ADDENDUM 1

ADDENDUM DATE: November 05, 2024

PROJECT: Onslow County Senior Services Center Renovation
4024 Richlands Highway
Jacksonville, NC 28540

1 STRUCTURAL RENOVATION PLAN - AREA A
S1-01 1/8" = 1'-0"

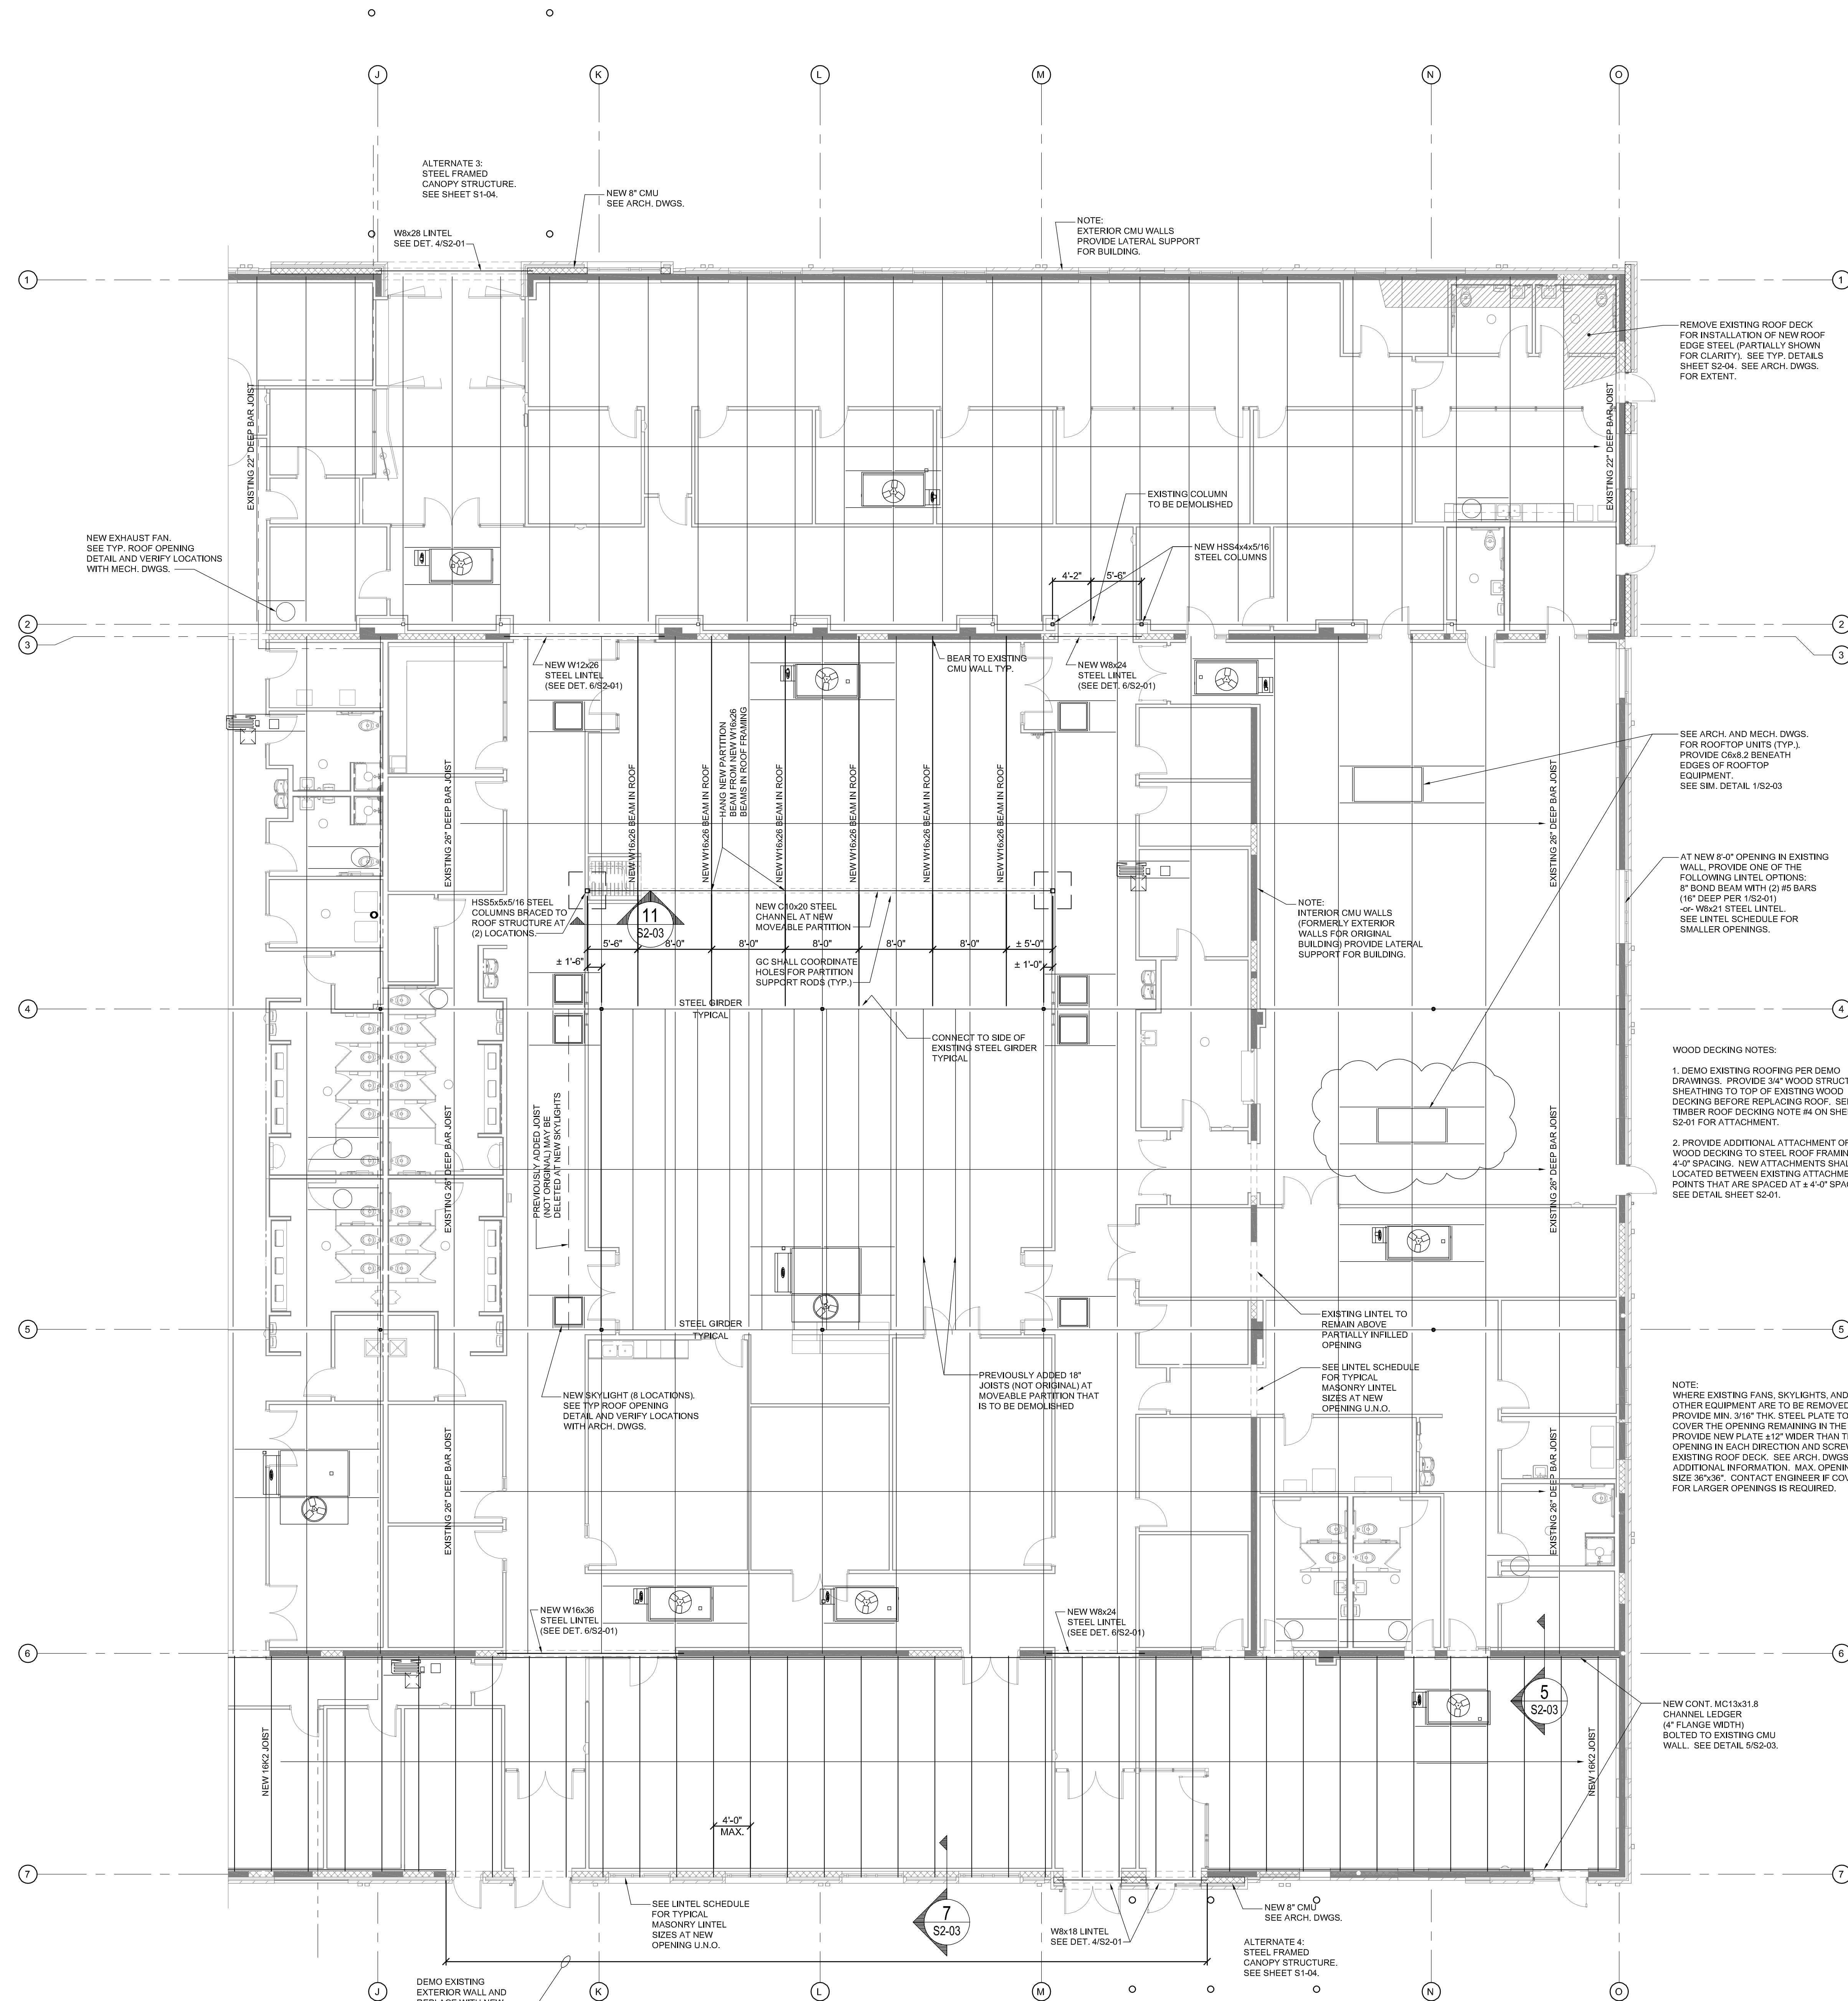
- Item 8 Sheet S1-01: REPLACE the sheet in its entirety with the attached sheet S1-01.
Note the following revisions:
- 1/S1-01 – Revision to location of RTU at congregate dining 106.
- Item 9 Sheet S1-04: REPLACE the sheet in its entirety with the attached sheet S1-04.
Note the following revisions:
- 2/S1-04 – Revision to dimensions of Alternate 4 canopy structure.

1
A0-02 DEMOLITION FLOOR PLAN - AREA A
1/8" = 1'-0"

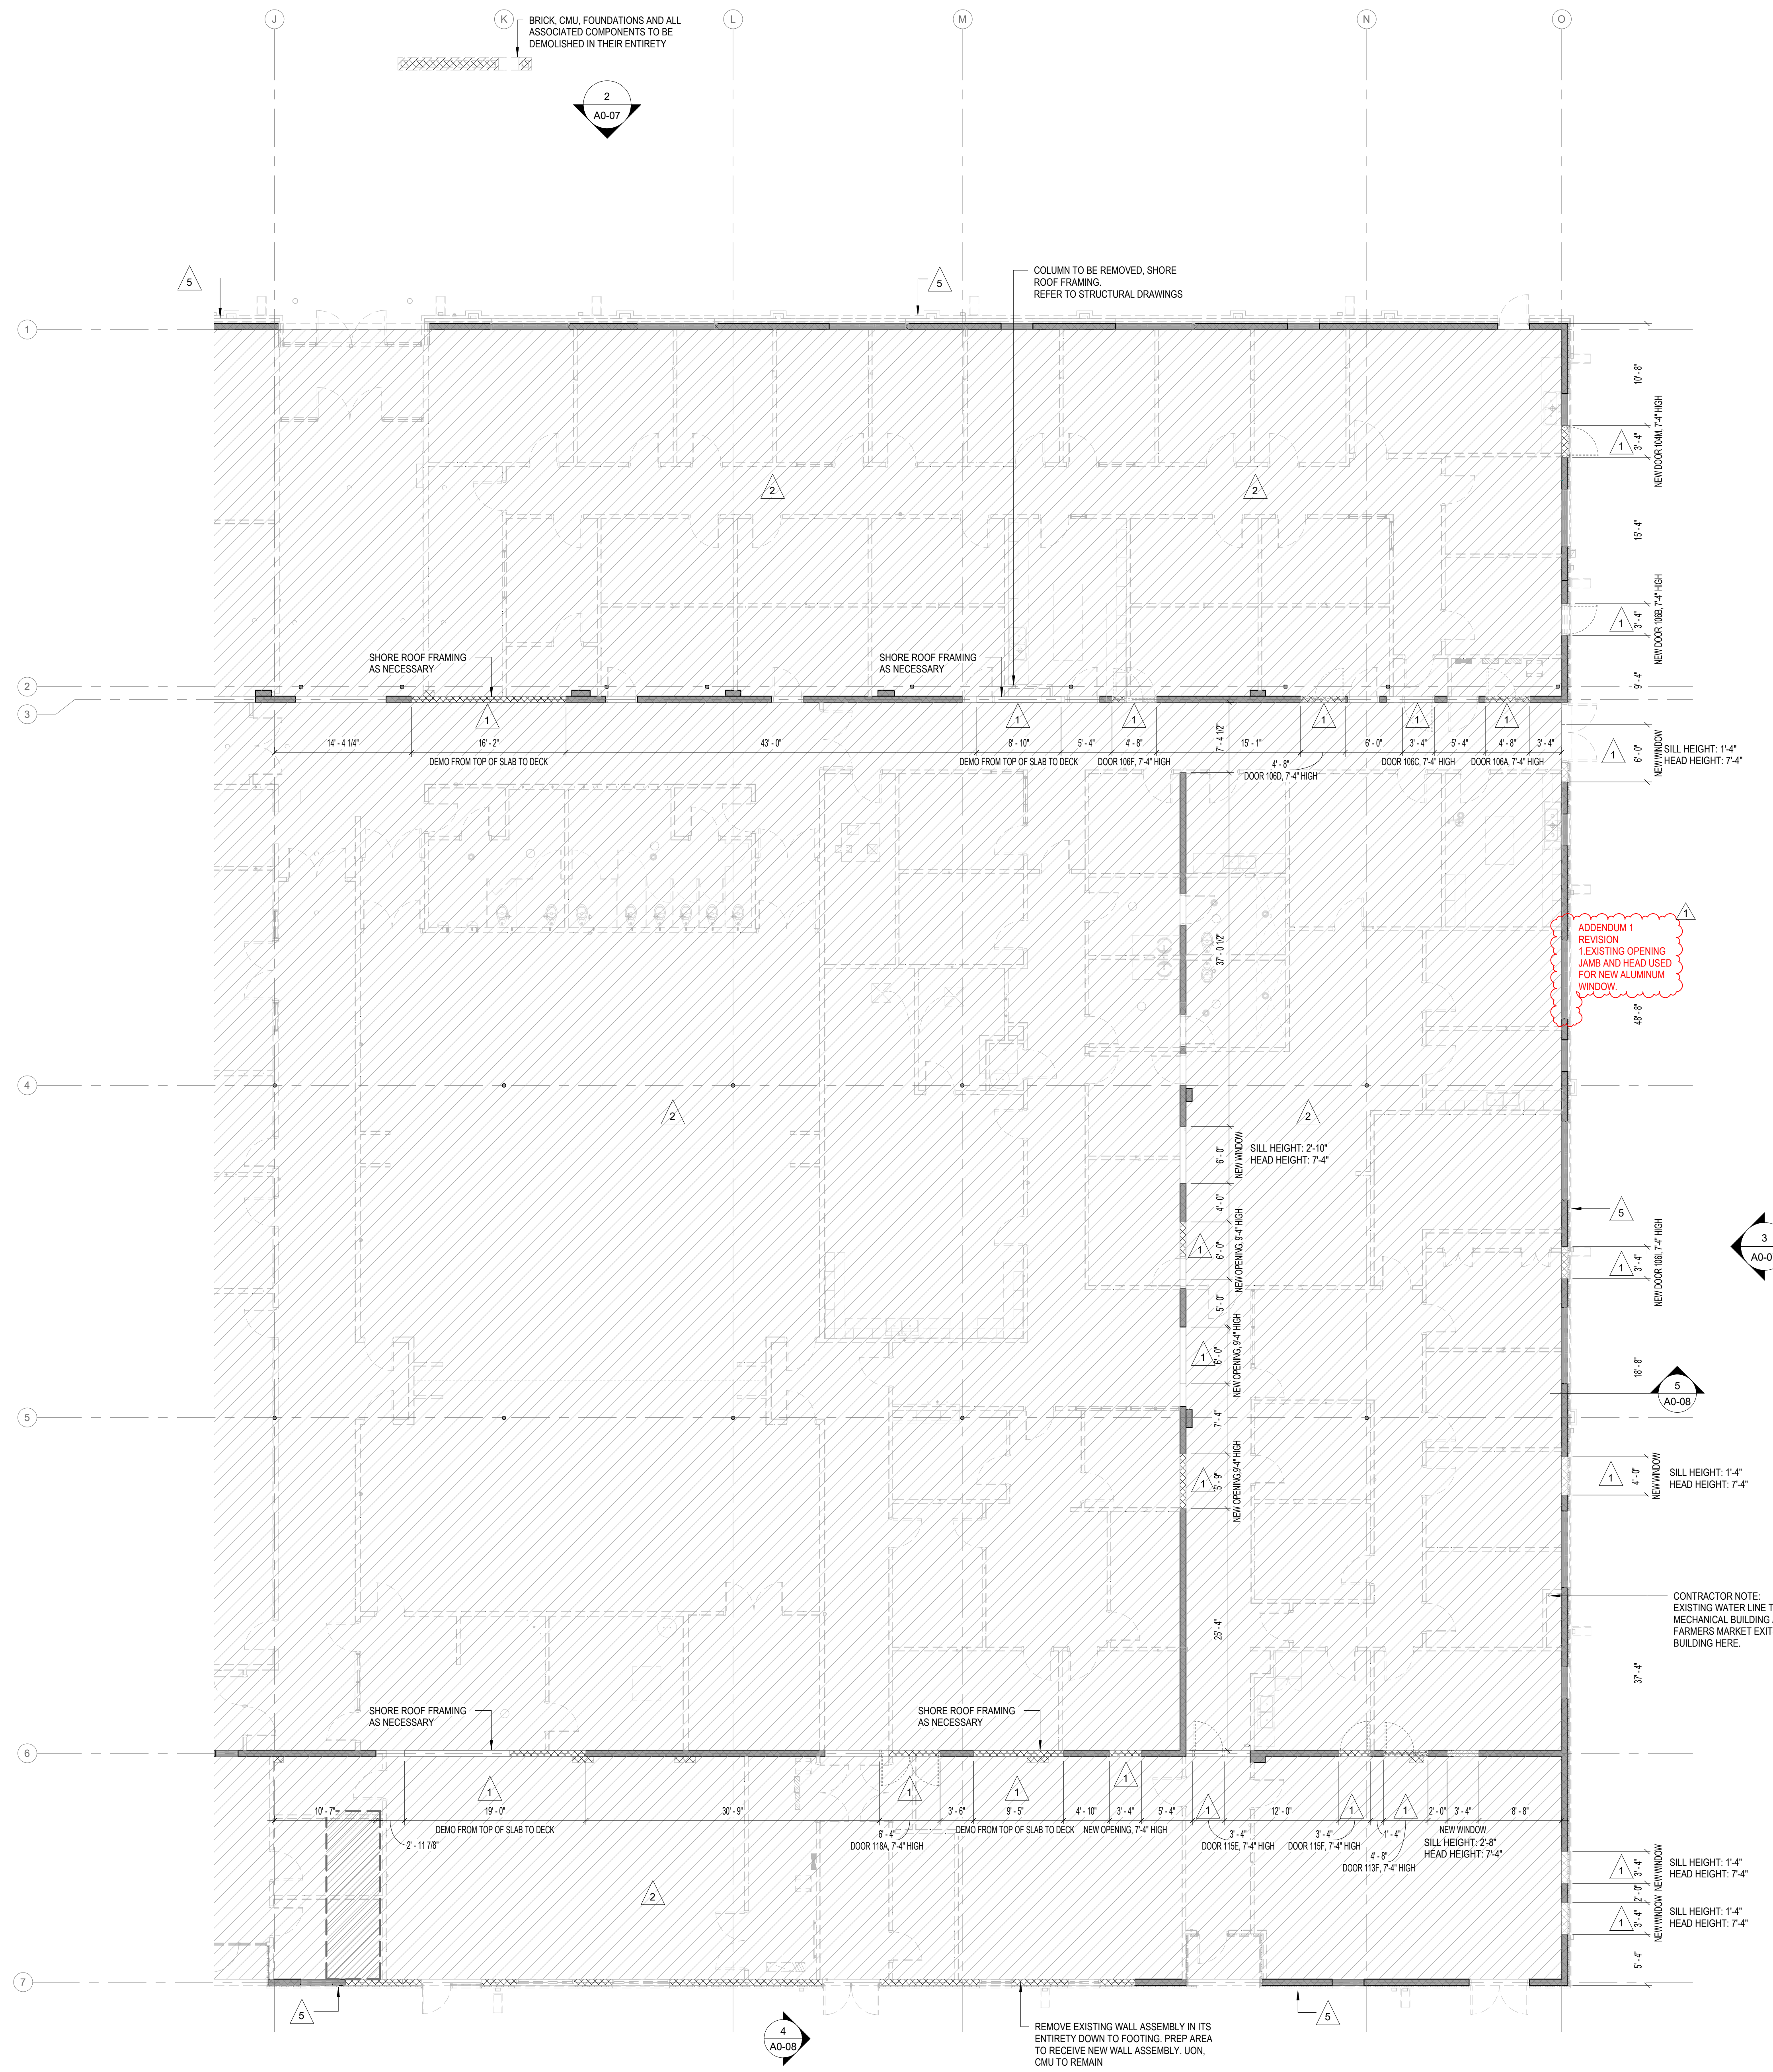
- Item 11 Sheet A0-02: REPLACE the sheet in its entirety with the attached sheet A0-02.
Note the following revisions:
- 1/A0-02 - Use existing opening head and jamb in lieu of a new opening in the existing wall for new aluminum window. Refer to demo elevations, A0-07.

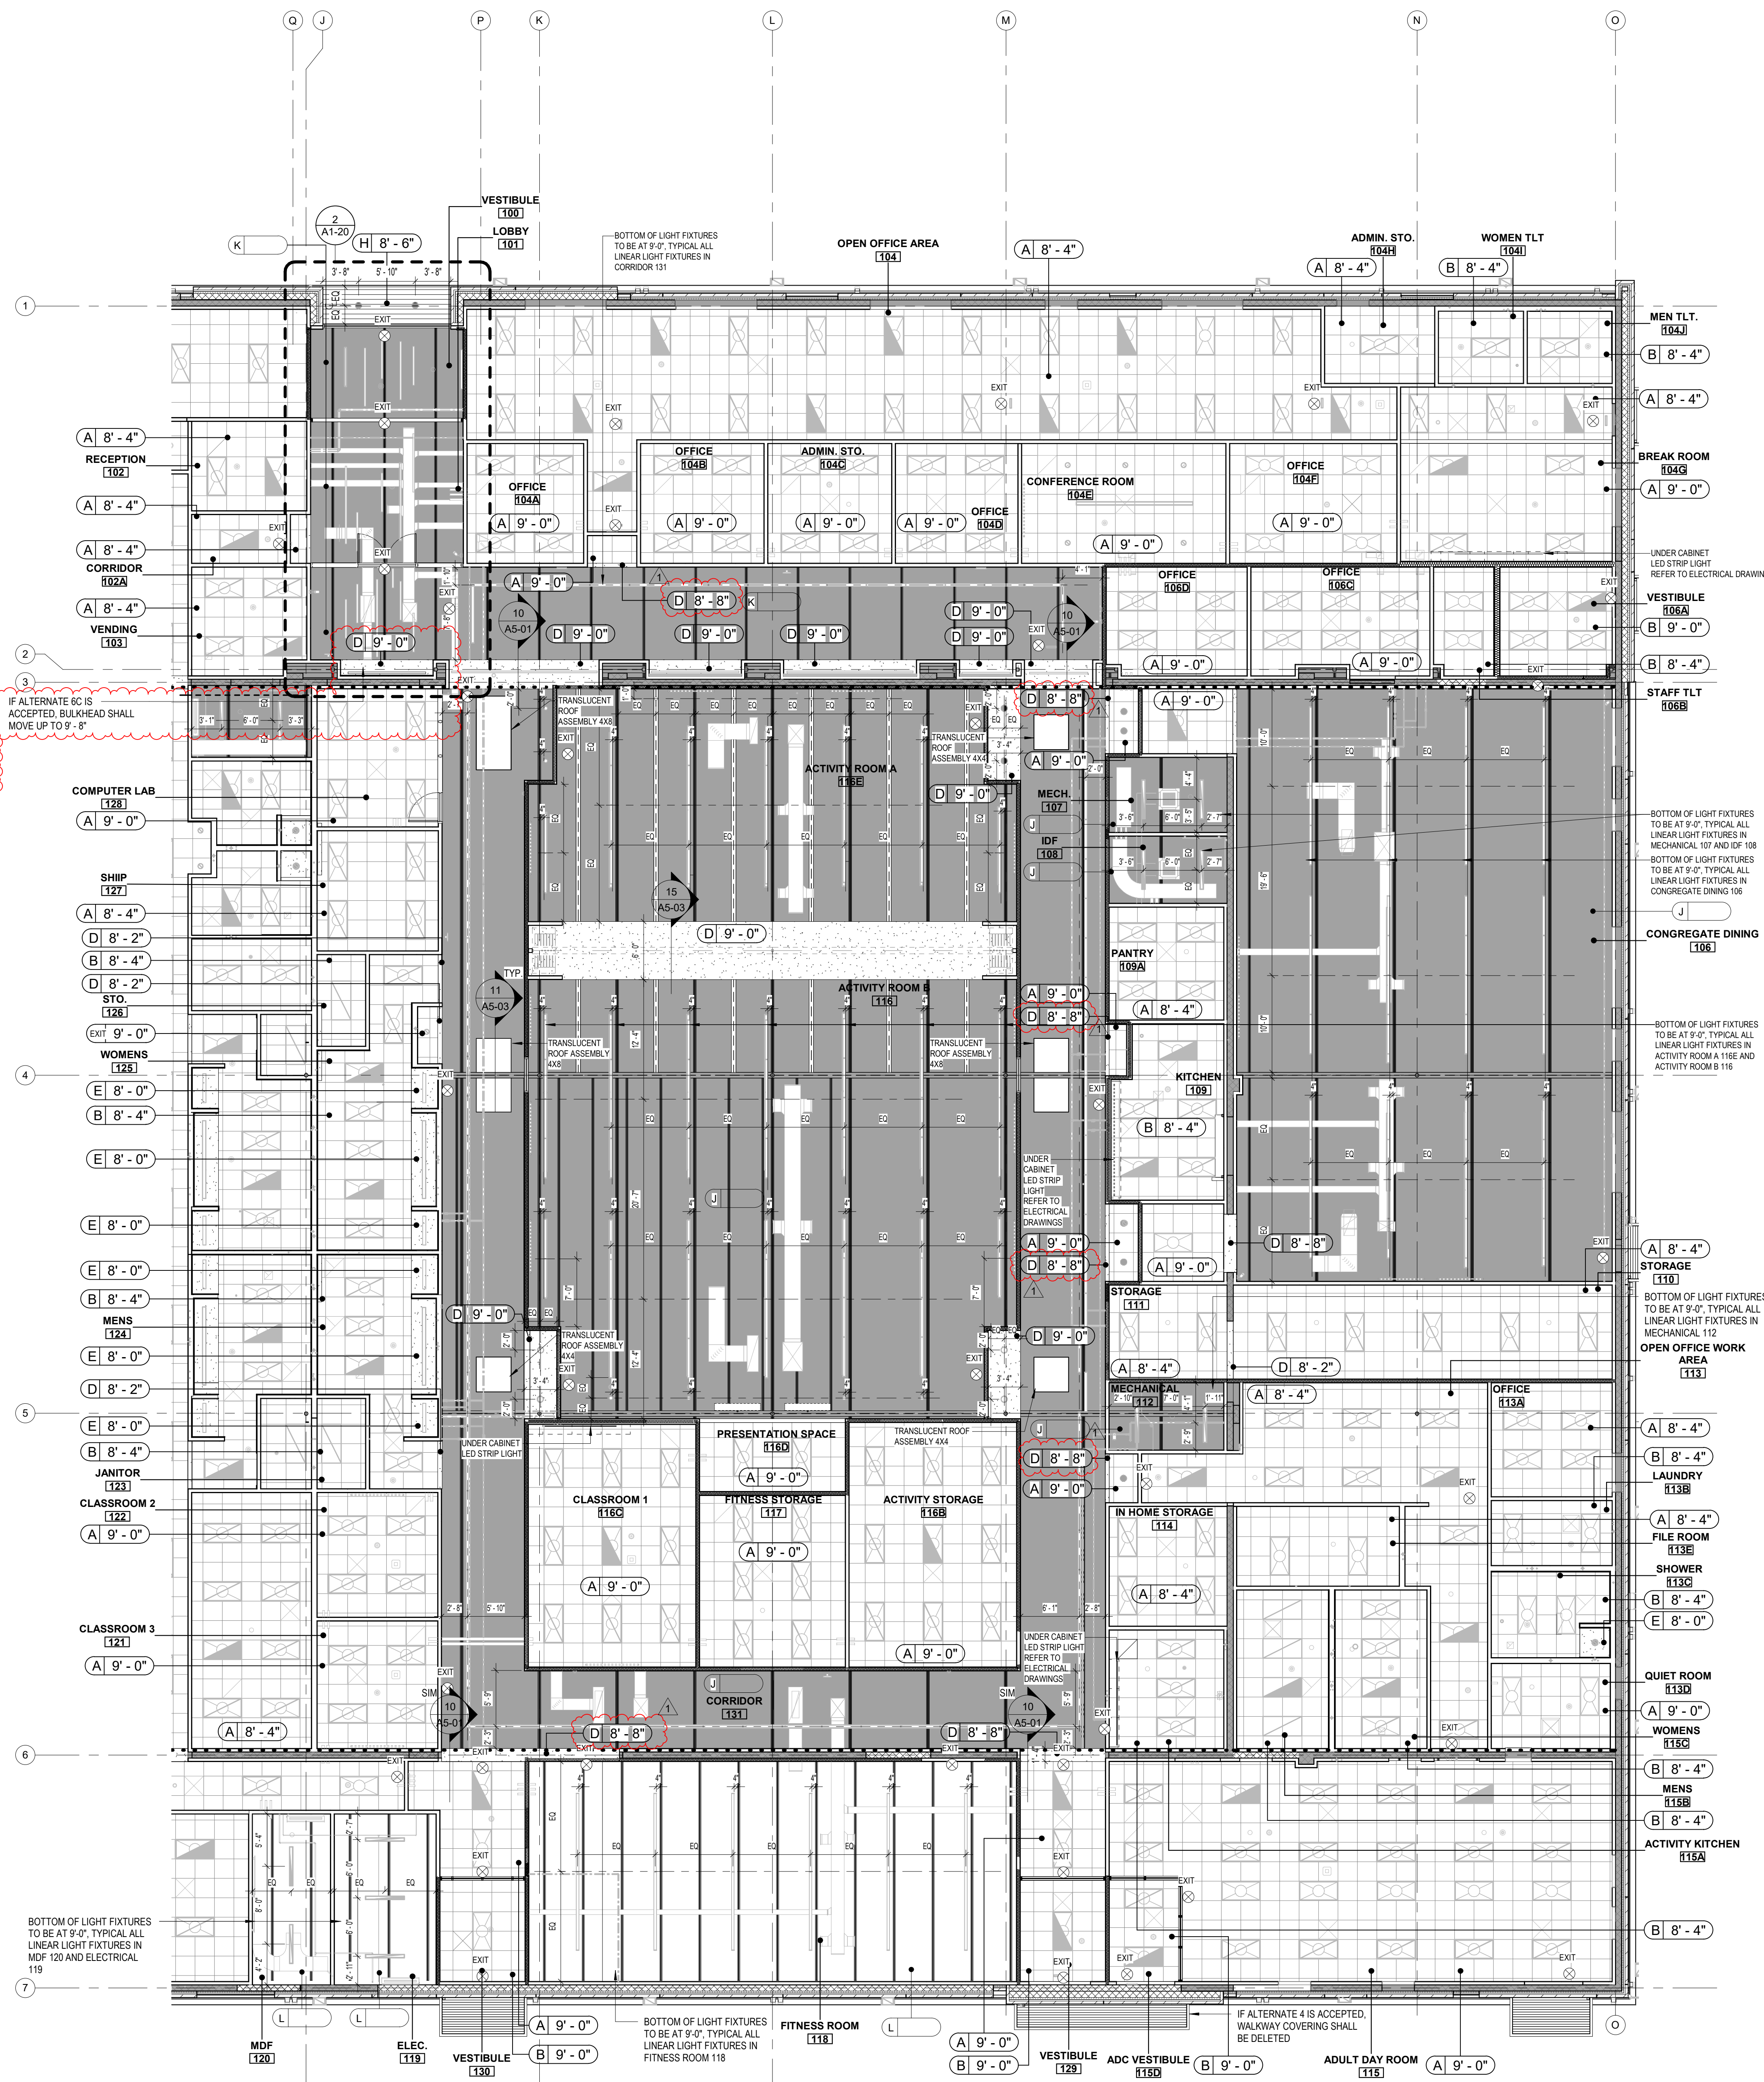
- Item 16 Sheet A1-20: REPLACE the sheet in its entirety with the attached sheet A1-20.
Note the following revisions:
- 1/A1-20 - Clarification – If alternate 6C is accepted, bulkhead height shall be 9'-8".
 - 1/A1-20 - Revision to bulkheads heights throughout area A as indicated on 1/A1-20.

ADDENDUM 1 REVISION
 1. IF ALTERNATE 6C IS ACCEPTED, BULKHEAD HEIGHT SHALL BE 9'-0"
 2. REVISIONS TO BULKHEAD HEIGHTS AS INDICATED ON PLAN
